Representation for EN 010137

Rebecca Face affected party 20048555

I am writing to expand on my initial objection to the Mona offshore wind farm project.

Figure 1

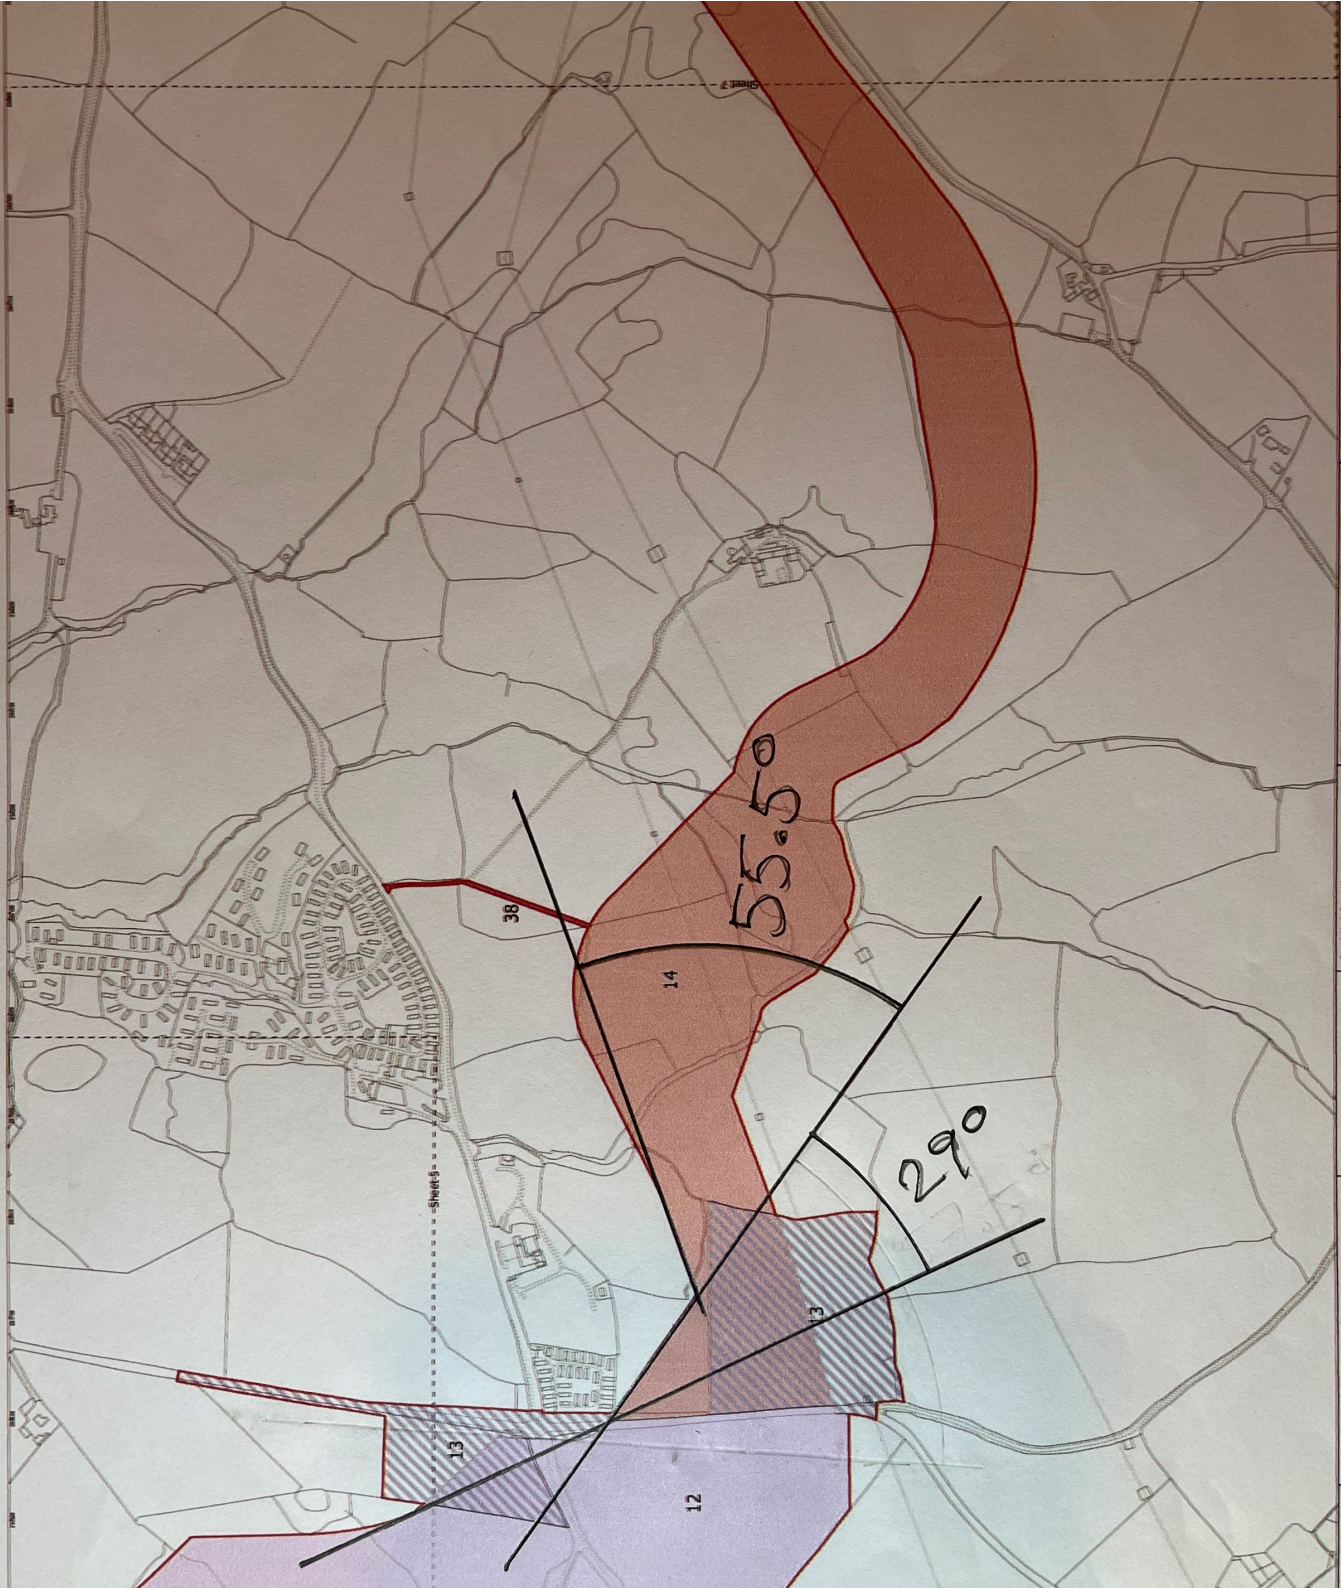
The surface water, once ejected from the underground fractures, is then channelled through pipes under the road to the outlet at the boundary between plot 06-097 and the small house on the west side. The surface water then flows between the house land's boundary and the ancient woodland, (see picture 1). The water flows along the riverbed until it runs across the flat wetland on the base of the valley between the two steep valley sides of ancient woodland (see picture 2).

My second concern is the spring within the field, (see picture 1). The problem is essentially the same as for the road springs, any ground disturbance will move the spring. It's location is the road's edge. It would only need to move a few inches and it will no longer flow across the field it would flow down the road or into the field across the road, leaving this land parcel with no water for either livestock or horticulture, which will force the closure of the farming business.

Structure 3

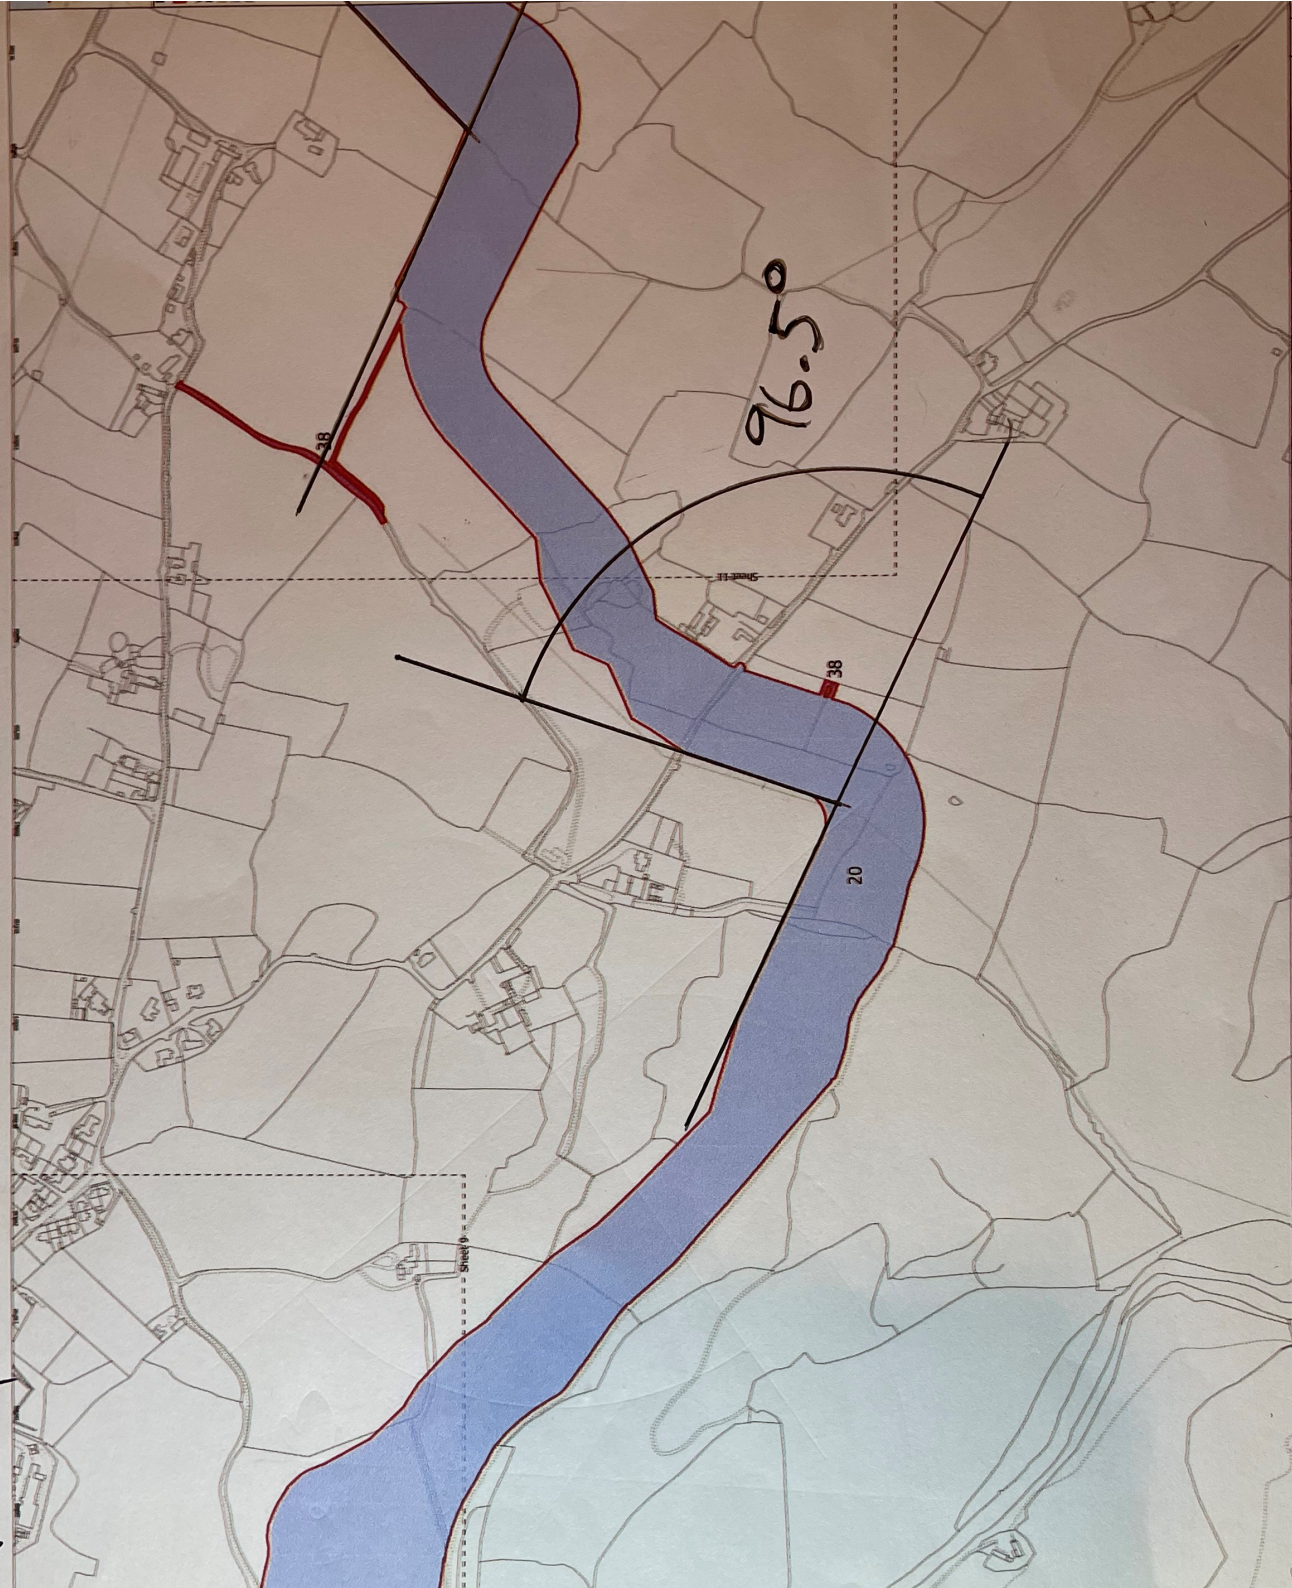
During my discussions with the applicant, the only reason they have ever given me for the extra width that they're asking for at this location, is that they want to avoid a "hard bend". The angles of turn between TCC2 and TCC3 are 29 degrees and 55.5 degrees (see picture 3). This is a very gentle sweeping curve which will not be altered by reducing the width of the corridor. This is in comparison to a 96.5 degree bend followed by a 68 degree bend on works plan onshore sheet 10, (see picture 4) and an 100 degree bend on sheet 7, where the corridor appears to be at its minimum width of 74 m, (see picture 5).

This problem, and the following problems, can all be resolved by simply narrowing the corridor to keep all the cable trenches within 100m of the A548. This will give the applicant the max work area that they say they need and will give the springs the max possible buffer to prevent damage.

6

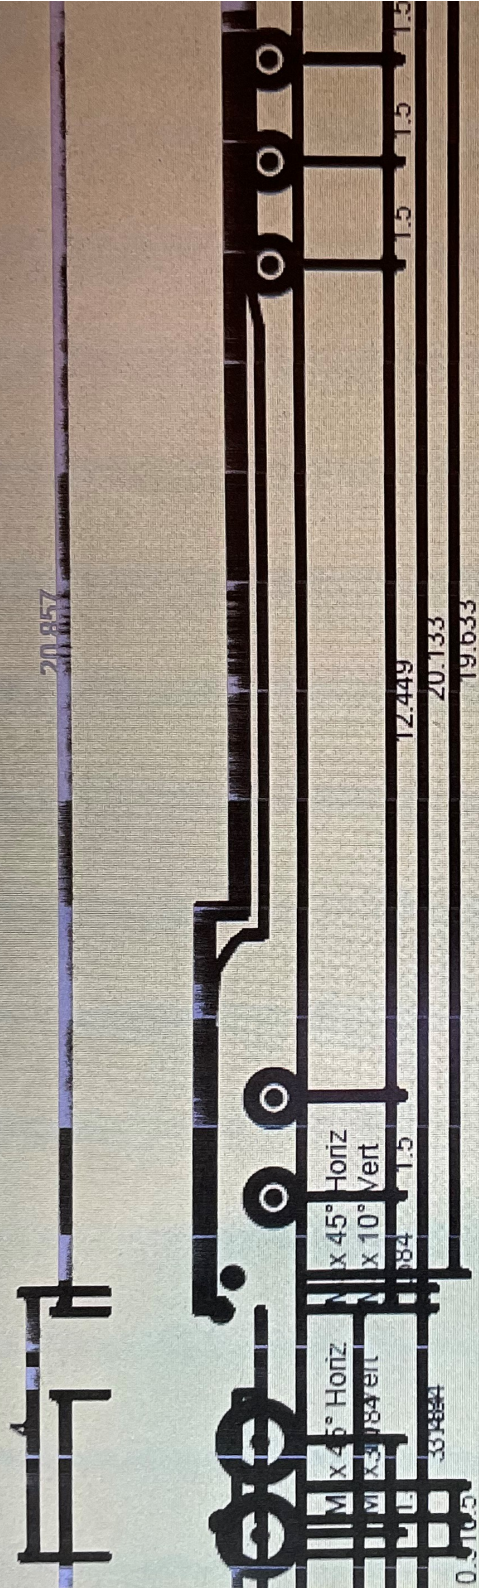
The third biggest concern is the access gateway into TCC2. The simple fact of this issue is that the applicant's cable delivery truck will NOT fit through the gate. The specification of this truck is an astonishing 28.816 meters long by 4.5 meters wide, ( see picture 6). The gateway is 61 meters down the road, past a choke point, with an 85 cm high verge on the opposite side. To facilitate this truck getting through this gateway would require the complete removal of the verge and trees on the opposite side, or the expansion of the bell mouth to such an extent that there will

be no safe separation from the A548, and the removal of 30+ meters of bat feeding hedge. The drawings and descriptions in the application are hopelessly inaccurate.
